ATTACHMENT TO ACCOMPANY AMENDMENT NO. 0004 TO IFB DACW31-03-B-0012 DATED JUNE 12, 2003

CONTRACT NO.
DACW31-03-B-0012

TITLE AND LOCATION						CONTRACTOR											
C & O CANAL REWATERING PROJECT, CUMBERLAND, MD.																	
A C T I V I T Y N O	T R A N S M I T T A L N O	S P E C I F I C S E C T	D E S C R I P T I O N	P A R A G R A P H	G O V E R N M E N T C L A S S I F I C A T I O N	CONTRACTOR: SCHEDULE DATES			CONTRACTOR ACTION		APPROVING AUTHORITY				M A I L E D T O C O N T R A C T O R /	R E M A R K S	
						S U B M I T	B Y	B Y	A C T I O N	D A T E	D A T E	D A T E	D A T E	A C T I O N			D A T E

SK-C-10

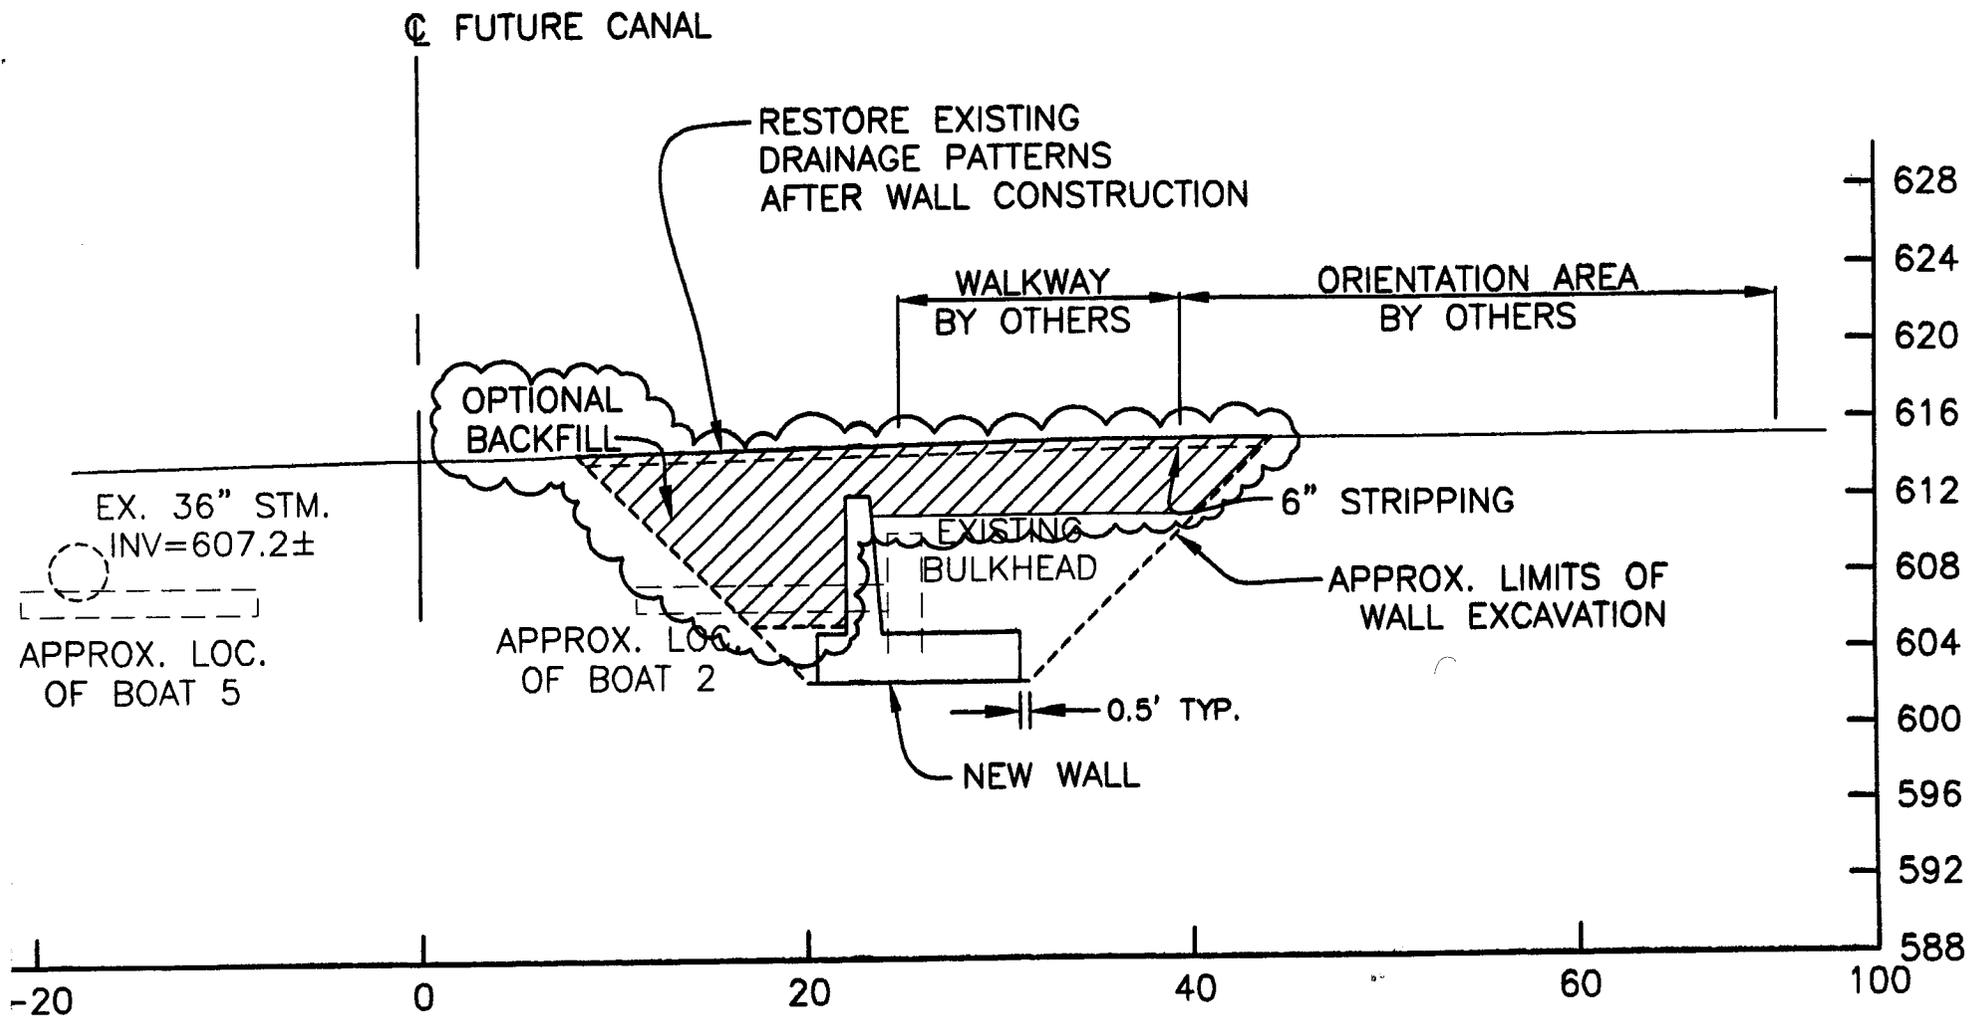
16. Plate 14, Sheet C-10: Revise this plate in accordance with the attached Sketch, SK-C-10, dated 11 June 2003. Wall backfill for the area shown on the sketch shall be a contract option. Bottom elevation of optional backfill is 605.4, just above the wall footing.

SK-C-11

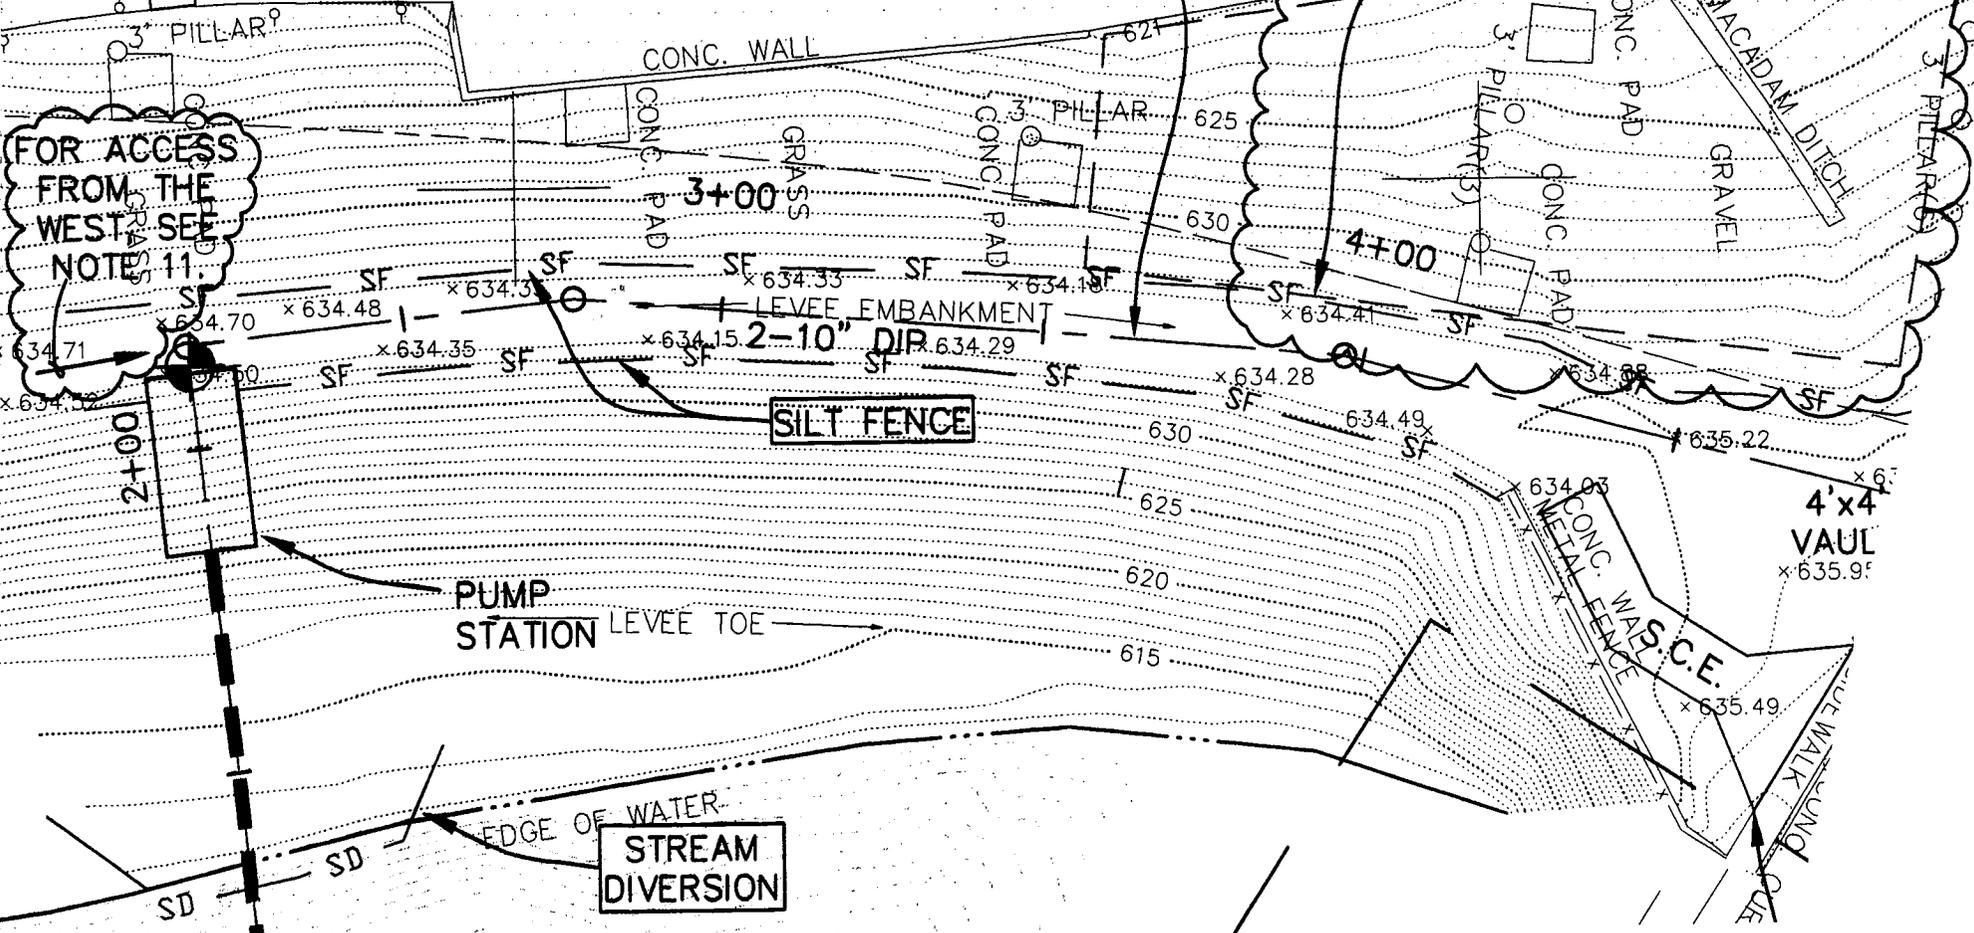
17. Plate 15, Sheet C-11: Revise this plate in accordance with the attached Sketch, SK-C-11, dated 11 June 2003. Wall backfill for the area shown on the sketch shall be a contract option. Bottom elevation of optional backfill is 605.4 on left side of wall, just above the wall footing. On the right side, bottom elevation of optional backfill is 1 foot below top of wall.
